The purpose of this report is to assess an application for a Development permit for a Material change of use to establish a Multiple dwelling (59 Units) and Food and drink outlet (1 tenancy) at 99-101 Old Burleigh Road, Broadbeach.

**DELEGATED AUTHORITY REPORT FOR DEVELOPMENT APPLICATION FOR
MATERIAL CHANGE OF USE (CODE ASSESSMENT) FOR A MULTIPLE DWELLING (59 UNITS)
AND FOOD AND DRINK OUTLET AT 99-101 OLD BURLEIGH ROAD, BROADBEACH
MCU/2021/603**

Figure 11 – Ground level podium setbacks. **Source:** Ferrochow.

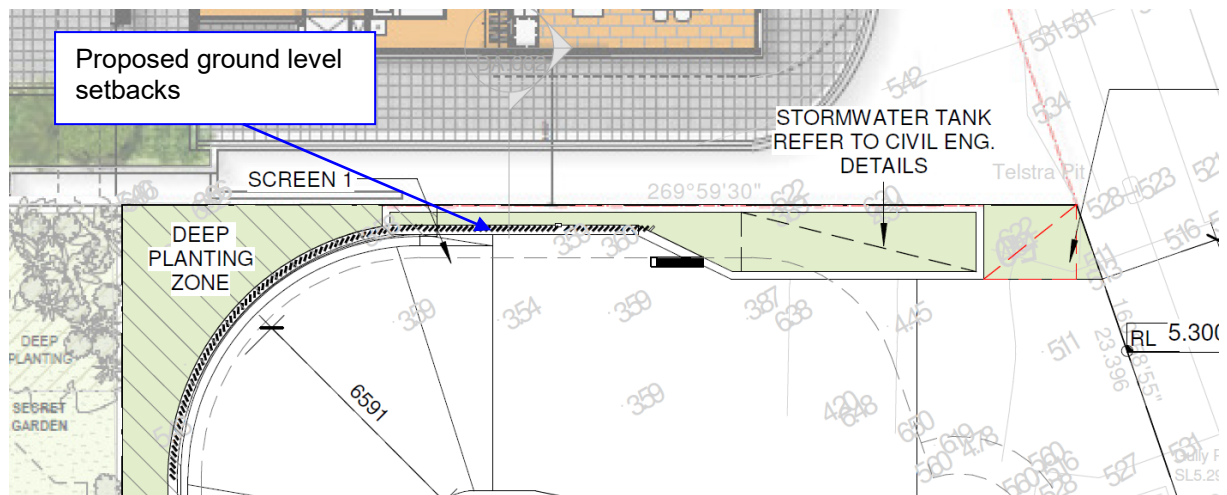
To the north, the ground level aspect of the podium (setback 0.6m from the adjacent boundary) is 2.7m high and 6.8m in width. This aspect allows for a narrow planter to establish a small but appropriate landscape buffer of the lower podium element.

Officers consider the extent of setback encroachment to the north to be negligible. The extent of impact is also considered to be offset by the proposed landscape outcome along the northern boundary and an appropriate architectural composition to assist in offsetting any perceived bulk.

Figure 16 – Comparison with adjacent approved podium. **Source:** CoGC.

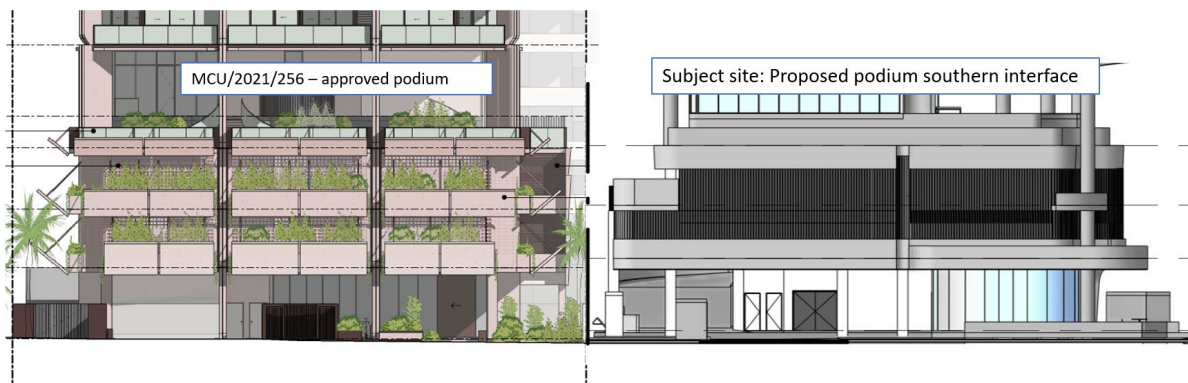
The below figure draws comparison to the proposed podium with that of the existing approved podium to the west. The setbacks for a podium of this scale are well supportable here and will reinforce the way in which offsets have been coordinated between approved forms.

In the above way, the proposed podium is appropriate in the existing context and when cumulatively considered against current planning approvals over the western site.

Figure 18 - Statement of Landscape Intent – Frontage Ground Floor (Left) & Level 1 (Right). Source: Urbis.

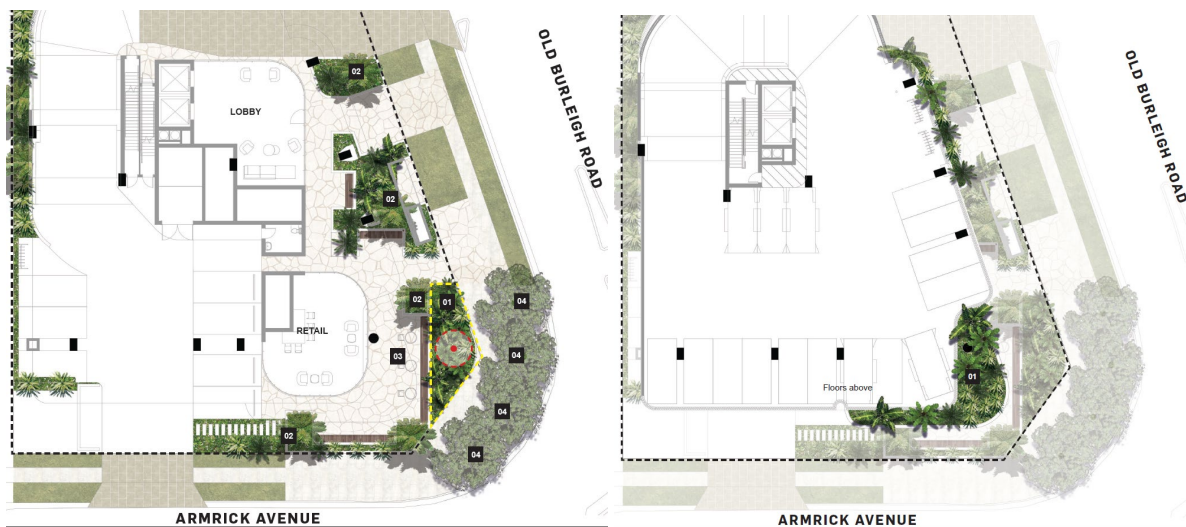
The proposed development incorporates several planting areas within the frontage to assist in softening the built form at the ground, first and second level, creating a tiered landscape effect as reflected in the below figure. The level 1 and 2 planters adjoining the streetscape will incorporate a combination of shrub and cascading plants while the south eastern corner frontage garden will support a large canopy tree to provide a direct visual contrast towards the remainder of the development when viewing from the adjacent Armrick Avenue and Old Burleigh Road frontages.

The proposed ground floor frontage garden incorporates deep landscaping to promote a high quality active pedestrian environment. Landscape Officers support the inclusion of a large canopy tree with a to further contribute to the streetscape.

Figure 19 – Rooftop podium landscaping. Source: Urbis.

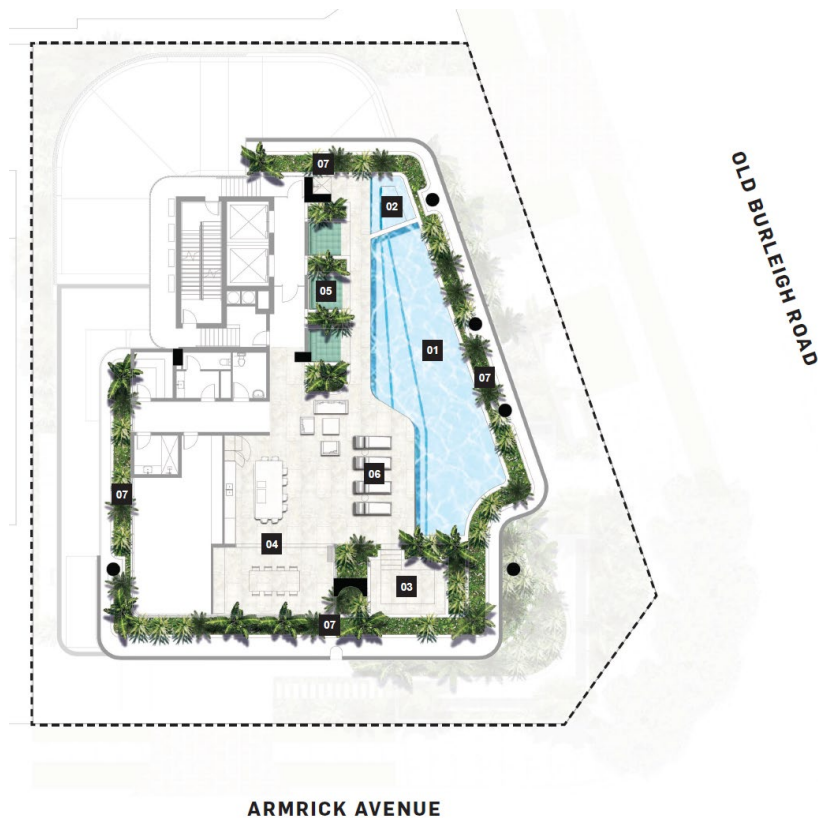
Atop the podium, the perimeter planting further defines the podium and accentuates an appropriate balance between green areas and built form.

Figure 20 – Lower tower form. Source: Ferrochow.

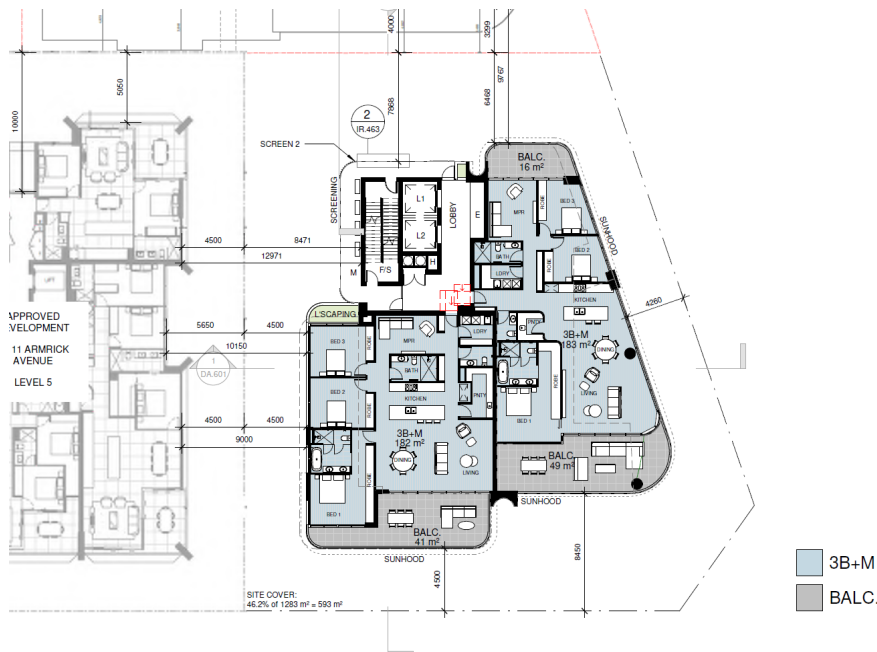
Setbacks for the height proposed will provide suitable separation distance to afford appropriate view corridors to be maintained between buildings to the north where tower separation of 9.6m will be observed up to the height of the existing, recently completed adjoining development. To the west, Officers have had the benefit of ensuring a coordinated response to tower separation is provided with the recently approved tower at 9-11 Armrick Avenue (MCU/2021/256). Setbacks of that approved development coupled with the proposals will allow for tower separation between 9m and 13m.

The below figure shows the tower offset. The figure further below does not include adjacent development as there are no towers of the same scale as this proposed herein. Notwithstanding, the proposal reduces its tower floor plate upwards from level 23, which accentuates the lower forms relationship with adjacent existing and approved towers while reinforcing the clear intent by the City Plan for tower bulk to be reduced as height increases.

Figure 21 – Tower floor plate above level 23. **Source:** Ferrochow.

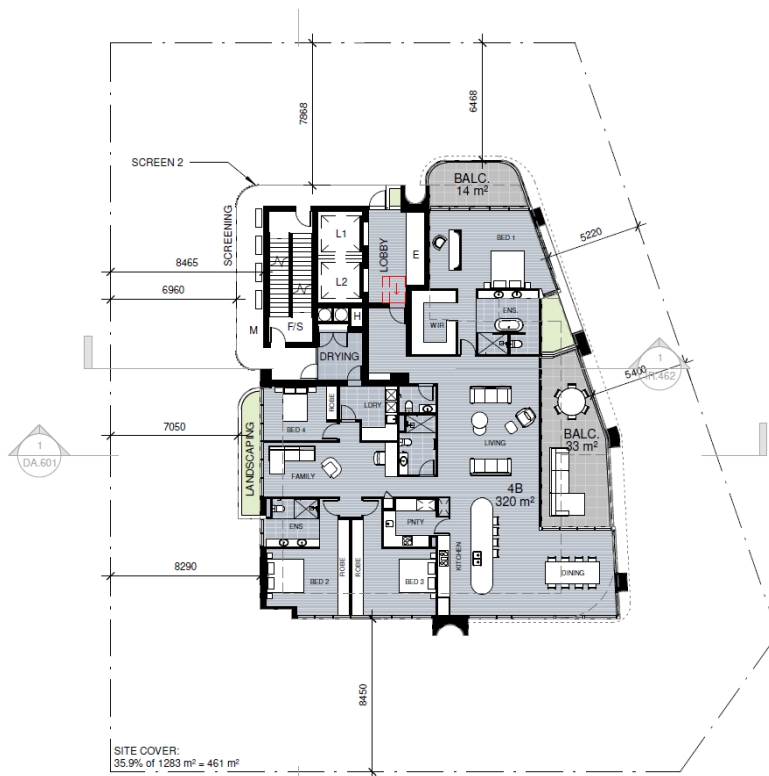
Collectively, City Officers consider the relationship between tower setbacks and building height delivers upon a form that is appropriate for the high rise, high intensity area of the city.

Figure 24 – Northern tower separation. Source: Ferrochow.

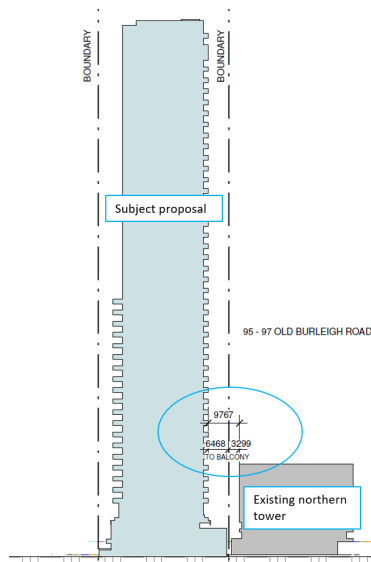
Immediately to the north, the site adjoins an existing 10 storey residential tower, while to the west the site adjoins an approved adjacent tower. It is apparent that the 25m tower separation provisions within Acceptable outcome AO5.2 are not capable of being achieved as considering the proposed setbacks and those of the northern and western tower (existing/ approved) separation distances will be lesser. This is visually shown below:

Figure 26 - Ground level Commercial tenancy. **Source:** Urbis.

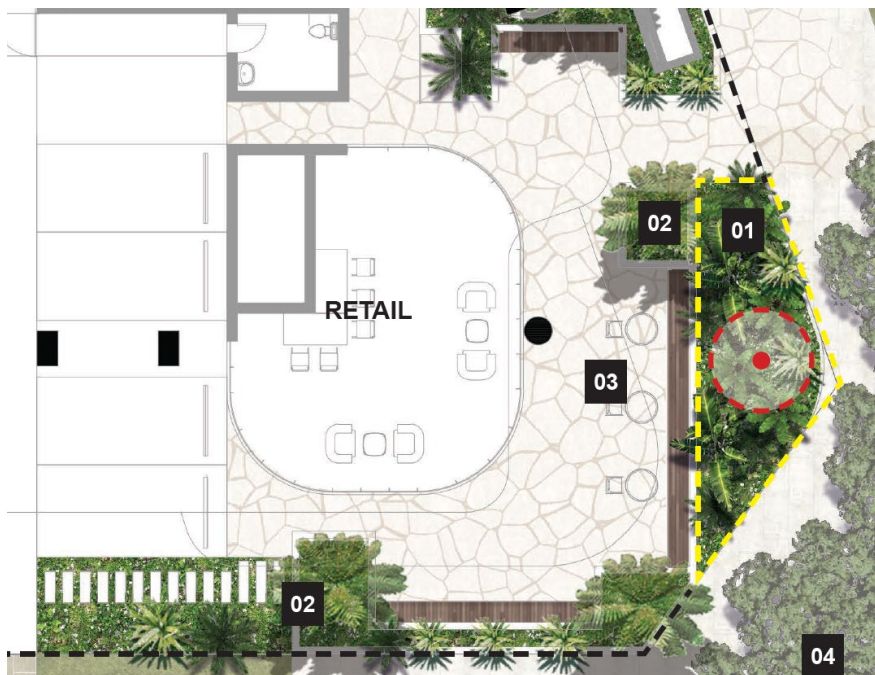
As no acceptable outcome is provided, officers have reviewed the land use provision against Performance outcome PO10. The proposal involves a ground level Food and drink outlet, the location and open nature will allow the end user of the tenancy to adapt to a use that provides direct services to support changing community needs within the blanket 'Food and drink outlet' land use (i.e. café, coffee shop, kiosk, milk bar, restaurant, snack bar, take-away, tea room) including indoor and outdoor dining opportunities to engage and activate the Armrick Avenue and Old Burleigh Road corner. Should a different commercial use be proposed under separate cover, the open nature of the tenancy will allow the use to appropriately adapt.

The proposal complies with Performance outcome PO10.

Figure 27 – Point of variation from southern shadow. **Source:** Ferrochow.

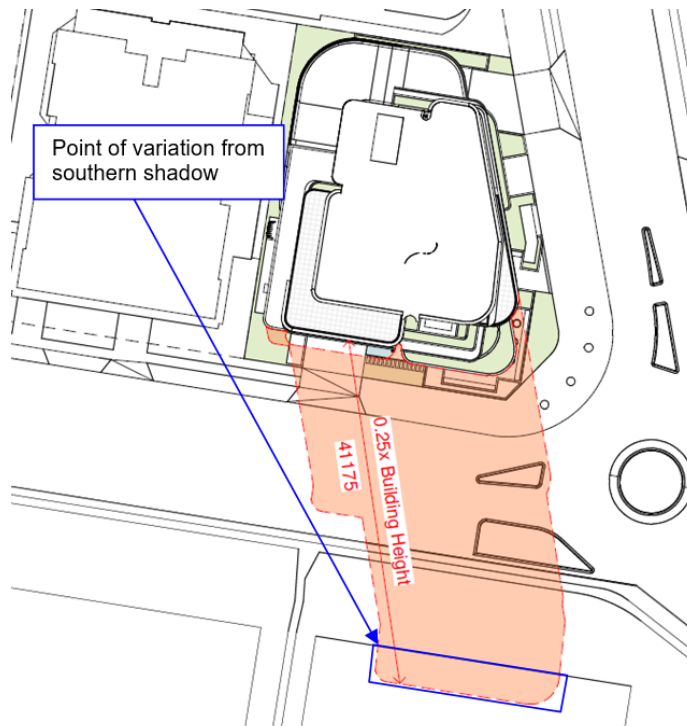
The shadow resulting from the proposed development does not achieve the above Acceptable outcomes due to the following:

- Southern shadow $0.25 \times 164 = 41\text{m}$. The buildings southern frontage setbacks will result in a portion of the southern shadow entering into the Broadbeach Bowls club site as shown below, thus AO8.2 is not achieved.
